Columbia Riverkeeper
1125 SE Madison St. Suite 103A
Portland, OR 97214

February 1, 2022

RE: Columbia Riverkeeper Comments on the Draft Waste Incidental to Reprocessing Evaluation for the Test Bed Initiative Demonstration

Table 4-4. BBI Estimate of Key Radionuclides in Tank SY-101 Waste (Ci)

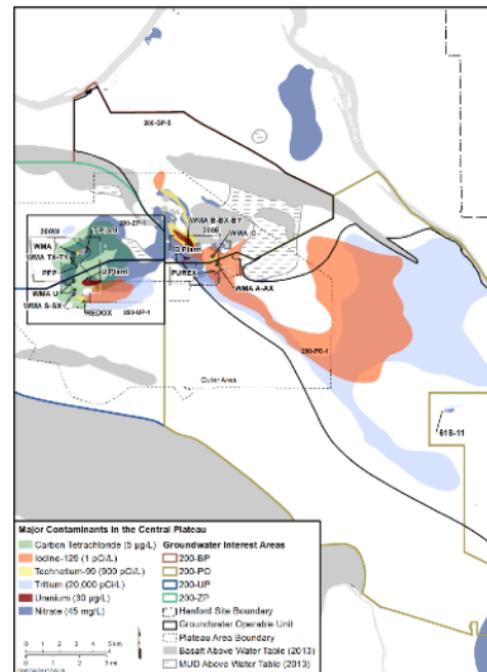
Despite previous and ongoing cleanup efforts, I-129, Tc-99, and other radionuclides and toxins are present in groundwater above standards at Hanford, and these contaminants are present in SY-101 material proposed for use in the TBI. According to page 4-10 of the Draft WIR, the TBI will handle material that could negatively impact groundwater and nearby communities if released.¹

The tank waste pumped in SY-101 and gathered for shipment in totes for shipping offsite to Perma-Fix will contain a variety of the contaminants above. Energy states, “In general...70% of the curies attributed to key radionuclides will remain in tank saltcake, which is roughly 19% of the tank waste by volume; the supernatant, which is roughly 81% by volume of the tank waste, contains only 30% of the curies from key radionuclides.”² If these expectations are not met, what are the consequences? Failure to remove key radionuclides could exacerbate risks as Energy moves the waste around the area. What happens if the grout doesn’t form correctly?
